Intel® Mobile Celeron™ Processor Specification Update

Release Date: May 1999

Order Number: 244444-004

Figure 2. Workaround Flowchart: SMBALERT#-Driven System

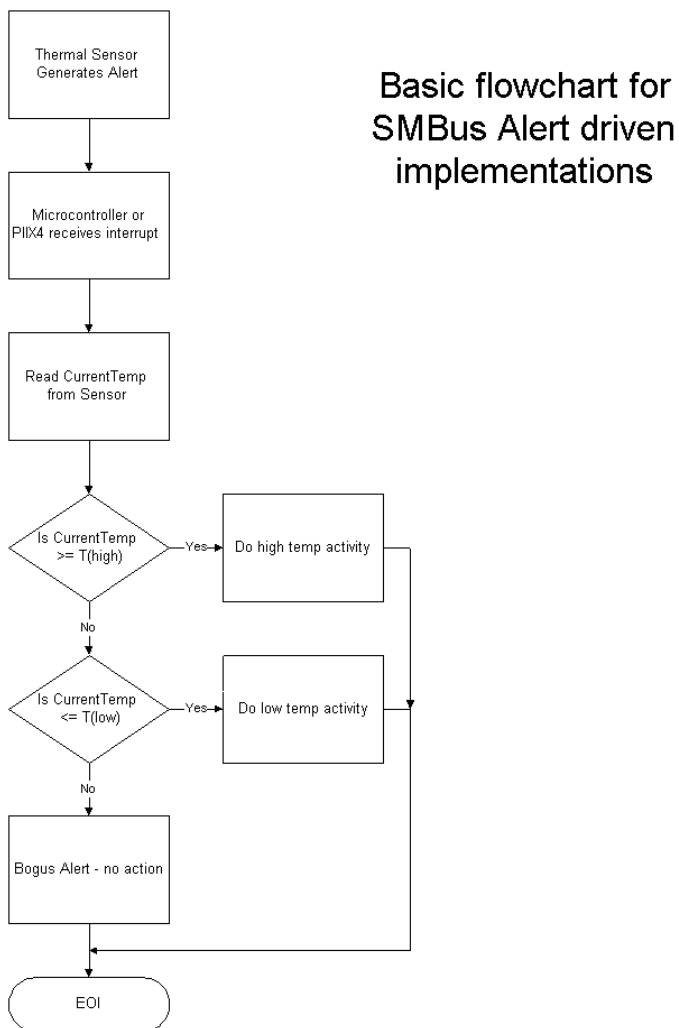
WORKAROUND: Three different (mutually exclusive) workarounds are possible:

1. Before servicing an interrupt from the thermal sensor, read and compare the processor thermal reading with the threshold limits (T_{HIGH} or T_{LOW}). Figures 2 and 3 provide basic flowcharts for the implementation of this workaround in an interrupt driven system.
2. If the firmware implemented polls the Status Register only, then before taking any action, re-read the temperature register and do a comparison with the alarm threshold limits (T_{HIGH} or T_{LOW}) to determine if the value is actually still within the temperature window.
3. Use a temperature polling scheme to monitor the processor temperature.
